# KENWOOD

## SERVICE BULLETIN

SUBJECT	DATE
TS-430S 500KHZ Hetrodyne	3.23.83

SUBJECT	TS-430S AM WIDE/NARROW FILTER SELECTION	DATE	12-8-83
---------	---	------	---------

Figure 1

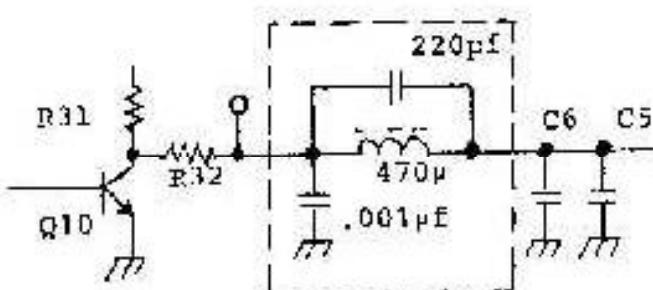
1. Remove top and bottom covers.
2. Turn radio bottom up and locate PLL Unit (X50-1910-00).
3. Remove the six (6) screws securing the PLL unit to the chassis and fold the unit over, to allow access to the foil side of the circuit board.
4. Remove the jumper wire that is installed between TP-1 and C6. Install the parallel circuit consisting of the 220 $\mu$ f capacitor and the 470 $\mu$ h coil in its place. See figure 2.
5. Install the .001 $\mu$ f capacitor as shown in figure 2.
6. Reinstall the PLL unit and replace the top and bottom covers.
7. No alignment is required.

FIGURE 1

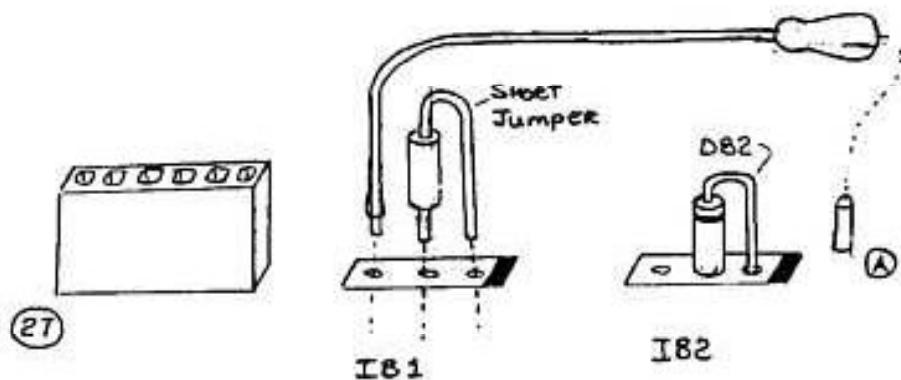
1. Remove the power connector from the radio.
2. Using a #2 Phillips screwdriver, remove the top cover (8 screws). Be careful of the VOX controls, and the speaker lead, which may be unplugged.
3. Loosen the two countersunk side screws and remove the 2 screws securing the IF unit bracket. Swing the bracket up slightly to access and remove the two heat sink screws. Swing the assembly down.
4. Remove 7 screws from the IF unit. Protect the top of the front panel from scratching.
5. Desolder IB1 and discard (use a 45 watt or less iron, and solder wicking).
6. Locate the white jumper wire that is plugged on to the "S" terminal of the IF unit. Desolder the wire from its present location, and reinstall as shown in figure 1.
7. Install a short jumper wire, as shown in figure 1.
8. Cut the foil paths as shown in figure 2. There are five

11. Check to see if D82 is installed, as shown in figure 1. If it is not, install it (181555). D83 should also be installed on the foil side of the board, as shown in figure 2.

Note: Some units have D82 and D83 installed, if so go to step 12.  
12. Move the filter select jumper to the "A" pin, as shown in figure 1.

FIGURE 2

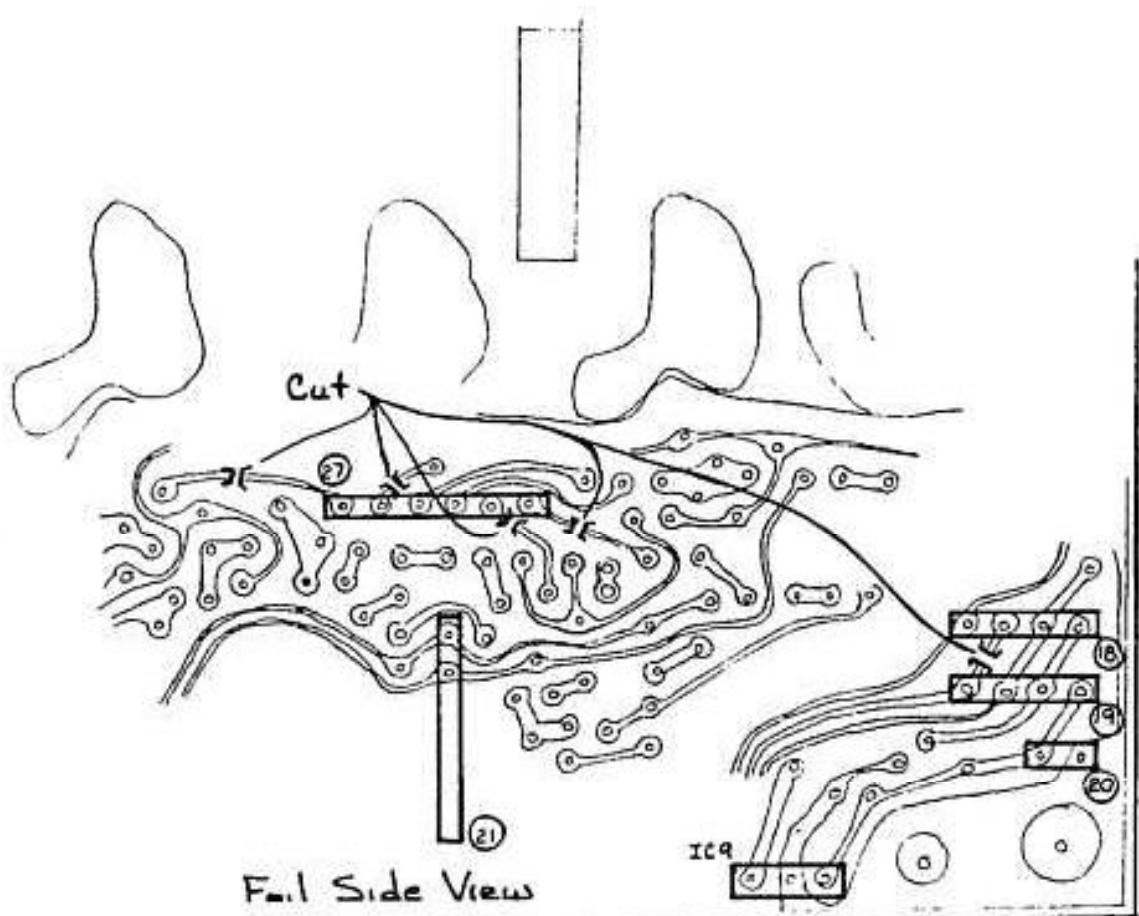
locations that must be cut. CAUTION: Ensure you cut only the traces as shown in the figure. Spend a little extra time to ensure you have correctly identified the trace to cut.

9. Install J401, J402 (may all ready be installed), J403, D403, D404, R403, R404, and R405 as shown in figure 2 (use the shortest lead lengths possible). Check to ensure there are no solder bridges, or splashes on the board.

10. Install Q401, Q402, R401, R402, D401, and D402 as shown on figure 2, again being careful to check for solder bridges, shorts, etc.

FIGURE 4

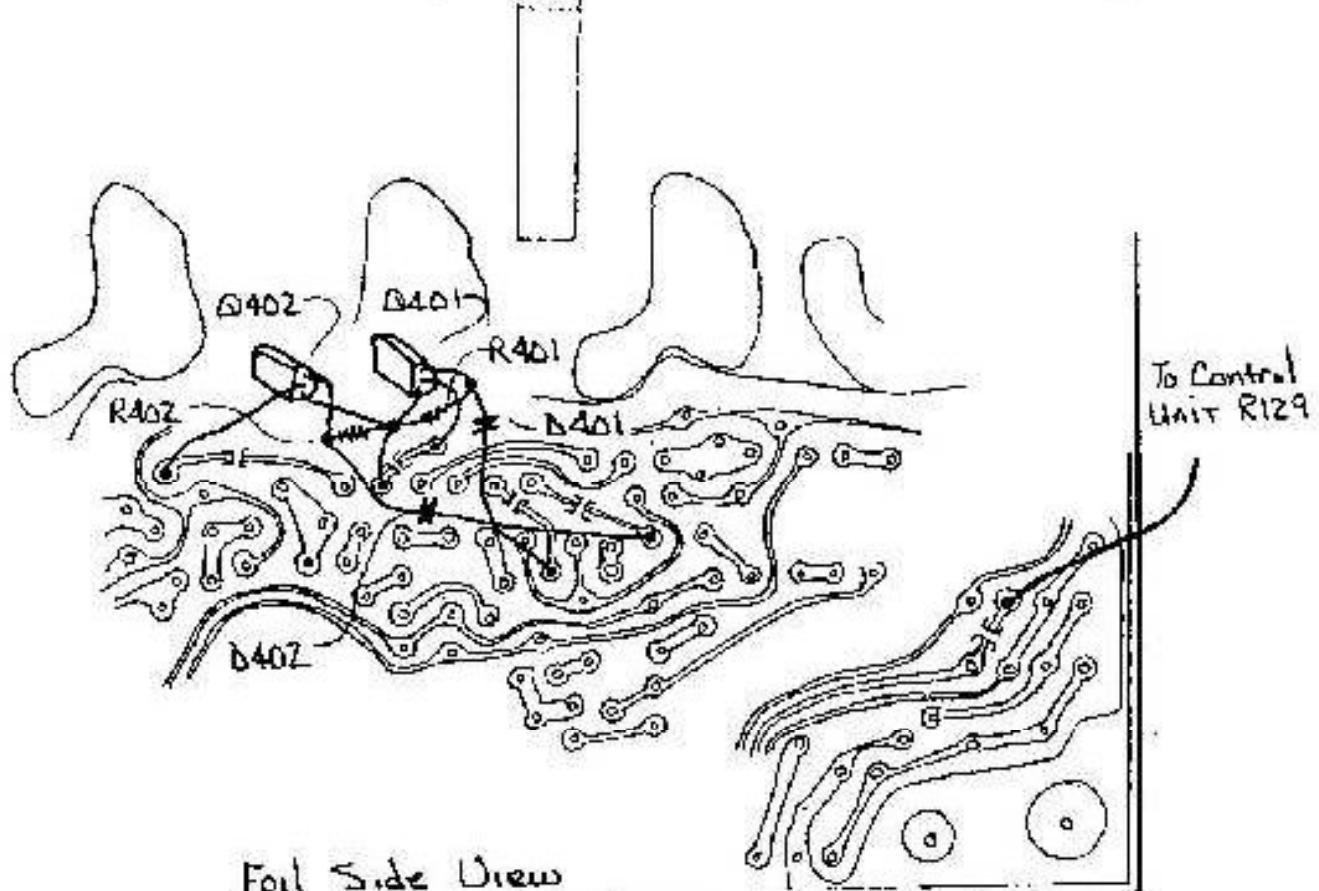
13. On Control Unit (X53-1290-00), cut the lead of resistor R129.  
14. Solder a jumper wire to the metal lead of resistor R129, as shown in figure 5. Connect the other end to IF Unit connector 18 pin 2 from the foil side of the board as shown in figure 4. The wire may be conveniently routed between the circuit board and the chassis.

SUBJECT TS-430S RECIEVER INTERNAL BEAT

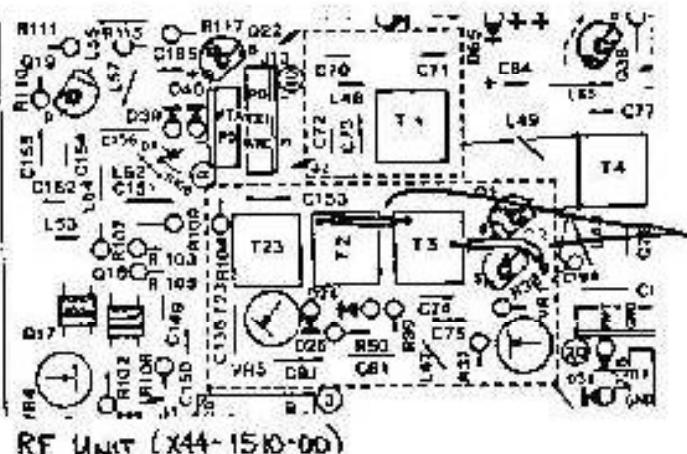
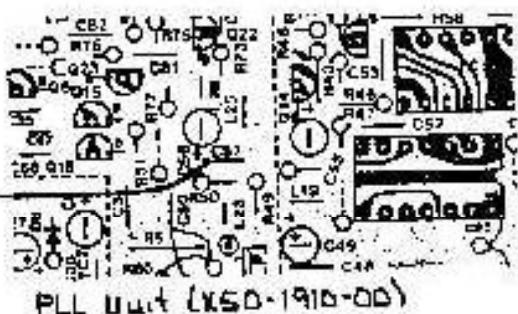
For reports of an internal beat at 28.415 Mhz or at 21.526 Mhz perform the following modification.

1. On the RF Unit (X44-1510-00) add a short jumper wire from the primary ground of transformer T2 to the primary ground of T3 as shown.
2. Add a jumper from the ground of the secondary of T3 to the ground side of capacitor C194, as shown.
3. Solder a jumper from the shield surrounding T1 to the shield surrounding T2, T3 etc. It may be possible to just bridge the two cases together with solder, either way is acceptable.
4. On PLL Unit (X50-1910-00) locate the position shown for capacitor C57. This capacitor was not installed at the factory, install a .01 uf 25v disc ceramic capacitor.

COMPONENT LOCATION

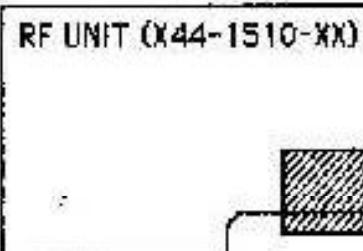
On the RF UNIT (X44-1510-XX) change the following components.

R80 change to a 100K $\Omega$  1/4 watt resistor (RD14CB2E104J)

R81 change to a 56K $\Omega$  1/4 watt resistor (RD14CB2E563J)

C125 change to a 560pF 25 v disc capacitor (CK45B1H561K)

CONTROL UNIT (X53-1290-00)

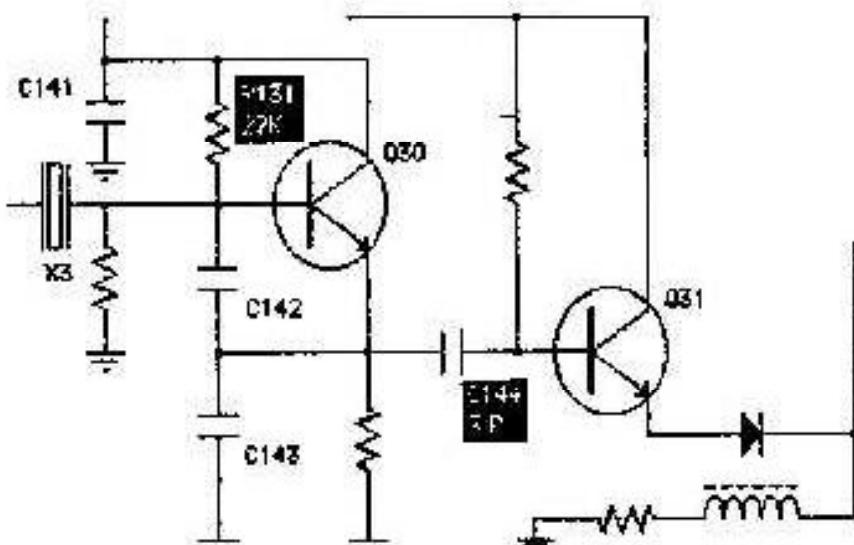
The cause of this may be due to a loss of the FM/AM Heterodyne Oscillator signal. Replacing the components listed below will correct most instances of this failure.

On the CONTROL UNIT (X53-1290-00) change R131 to a 22 K $\Omega$  1/4 watt carbon resistor (RD14CB2E223J), and change C144 to a 3 pF 25 v disc ceramic capacitor (CC45SL1H050C).

On the CONTROL UNIT (X53-1290-XX):

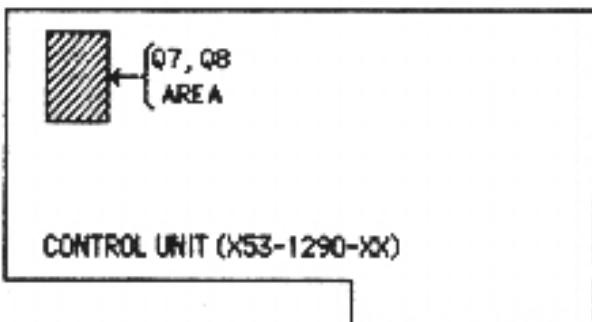
Check transistor Q8. If it is not a 2SC1815(Y) change it to this type (Serial numbers 408XXXX-509XXXX).

For serial numbers before 408XXXX change R29 to 820.0  $\Omega$  and C41 to 100 pF.

## II. Contact maintenance circuit installation.

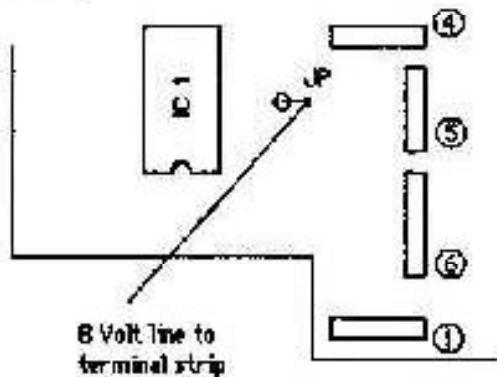
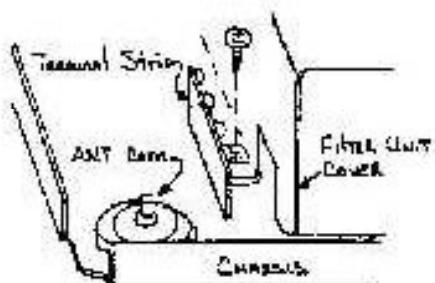
1. Disconnect the center lead of the coaxial cable from the antenna terminal.
2. Install the contact maintenance circuit as shown in the accompanying diagrams. Attach the terminal lug strip with one of the filter unit cover screws.
3. Solder the 8v lead to the "JP" terminal of the Filter Unit.
